ASSESSMENT REPORT

Section 75W Modification Eastern Creek Waste Facility (06_0139 MOD 3)

Figure 2 Modification components

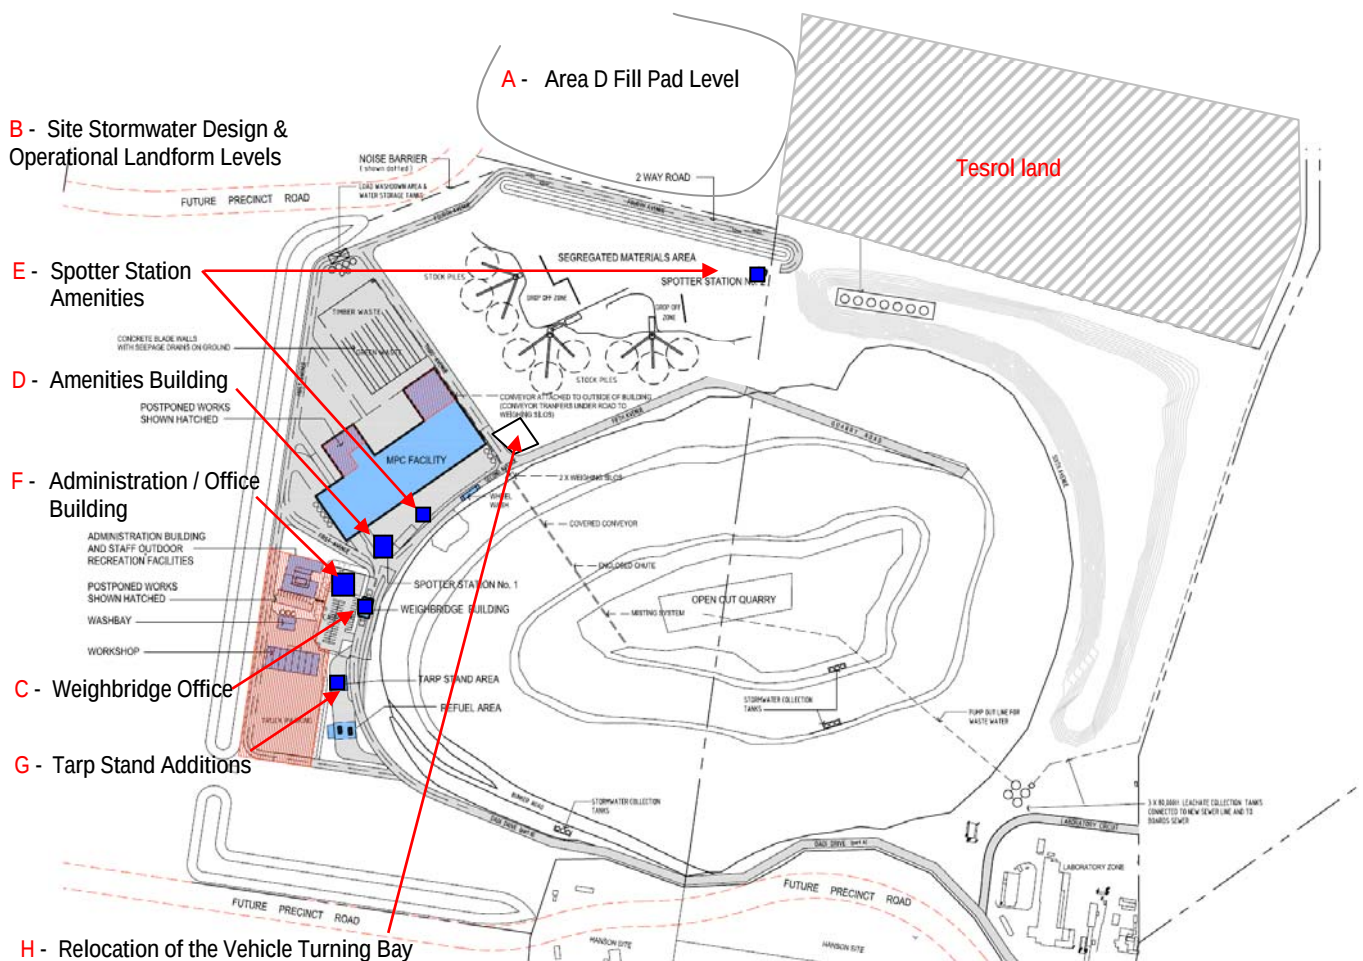
The proposed LandPartners operational landform plan provides for the Future (local) Precinct Road, however, it shows that the road would traverse private infrastructure (ie. Fourth Avenue) and the fill pad in Area D relevant to this project. (See Figure 5) The Department also notes that the site plan for the project is inconsistent with the LandPartners Plan with regard to the alignment of the Future Precinct Road. (See Figure 2 compared with Figure 5).

Figure 3: Extract of the fill pad in Area D from the approved 'Hyder Plans'

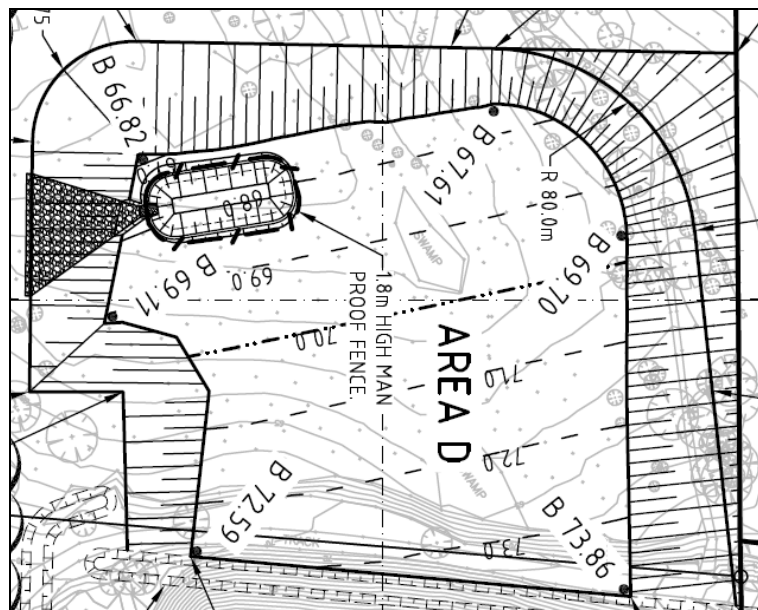
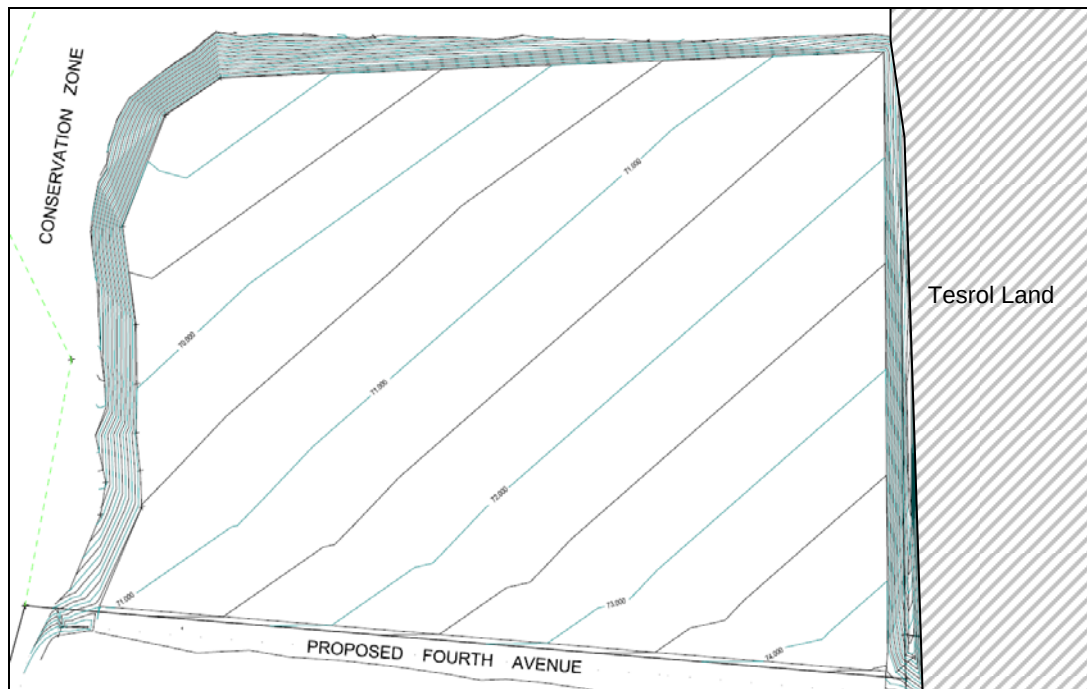
In regard to fill pad Area D the Proponent seeks approval for works that have been carried out to increase the final landform level from the level shown in Hyder Consulting Pty Ltd plan DA001-A dated 28 April 2009 (which formed part of the initial project approval), by up to 4 metres to the 'as constructed' levels shown in LandPartners plan 72757_Area D.

- surface water runoff in the area is directed to the north-west by the contours of the land. While this may be consistent with the current Precinct Plan for Eastern Creek, this could increase drainage flow into the existing conservation area if not captured;
- provision for adequate on-site detention for the site and adjacent to the north-western corner of the pad;
- drainage impacts to the adjoining properties;
- providing for the outcomes of the recent court imposed conditions in relation to final landform stormwater management system and catchment flows;
- achieving Council's stormwater performance criteria as detailed in Council's Stormwater Quality Control Policy and Precinct Plan for Eastern Creek; and
- maintain pre-development hydrological flows.

Figure 5: Excerpt from LandPartners plan showing ponding on Tesrol's land and the future precinct road

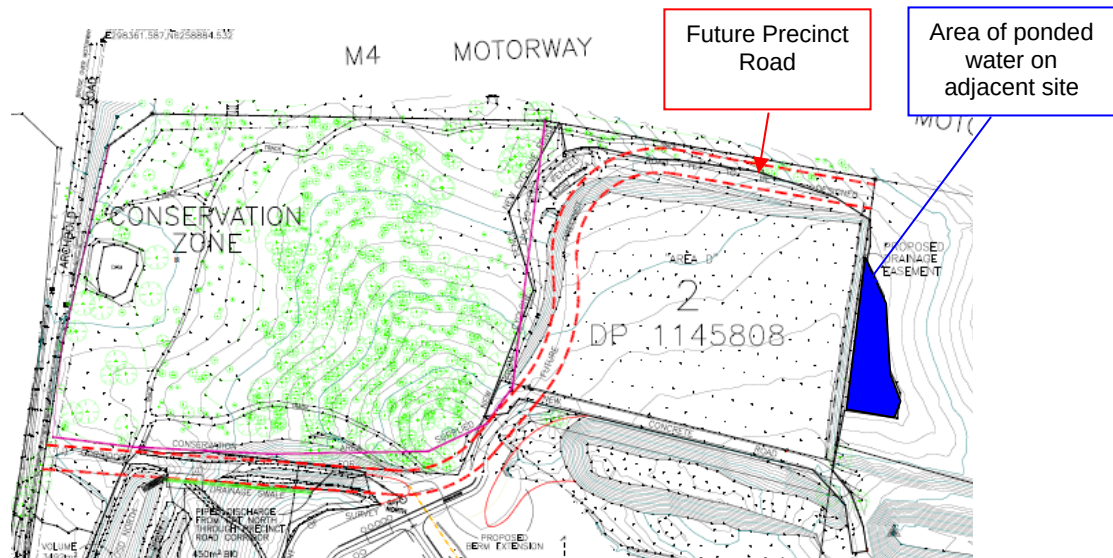
The Department and Council raised concerns regarding the area of ponding that would result on the adjoining land (Lot 9 DP 241859) owned by Tesrol (see Figure 5). While Condition 1 Schedule 4 of the project approval pertains to the final landform, as opposed to the operational landform, it does require that all earthworks required to reach the approved final landform shall be conducted without impacting on adjoining landowners.

Both the Department and Council raised concerns with ThaQuarry that the proposed LandPartners operational landform plan shows the future precinct road traversing private infrastructure relevant to the Project and the fill pad in Area D. The Department also raised concerns that ThaQuarry, or any subsequent owner of 'Area D', might at a later date, seek approval to construct the future Precinct Road within the conservation area or in close proximity to the conservation area both of which could possibly result in the removal of, and further edge effects to, the vegetation.

- they have entered into discussions with the Proponent regarding development prospects for the fill pad in Area D, particularly how the developed levels of Tesrol's land would interface with that of ThaQuarry and how stormwater drainage would be managed;
- the ponding, shown on LandPartners plan is temporary, since that area would ultimately be filled and Tesrol's land levels would be higher than those proposed on ThaQuarry's fill pad;
- a deed exists between ThaQuarry and Tesrol which makes various provisions for land levels and drainage easements; and
- drainage of this temporary ponding has been provided for along the boundary of Area D.

The Department understands Council recently approved a development application by Tesrol for final landform levels consistent with ThaQuarry's proposed fill pad level. Should the LandPartners plan be approved the level on fill pad Area D would provide for a consistent interface between the two sites.

The Department wants to be clear that it does not support encroachment of development within the conservation area, including any future precinct road. Therefore the Department notes that if the LandPartners operational landform plan is approved as part of this modification, it is likely that a further modification to the project approval would be required to accommodate the Precinct Road.
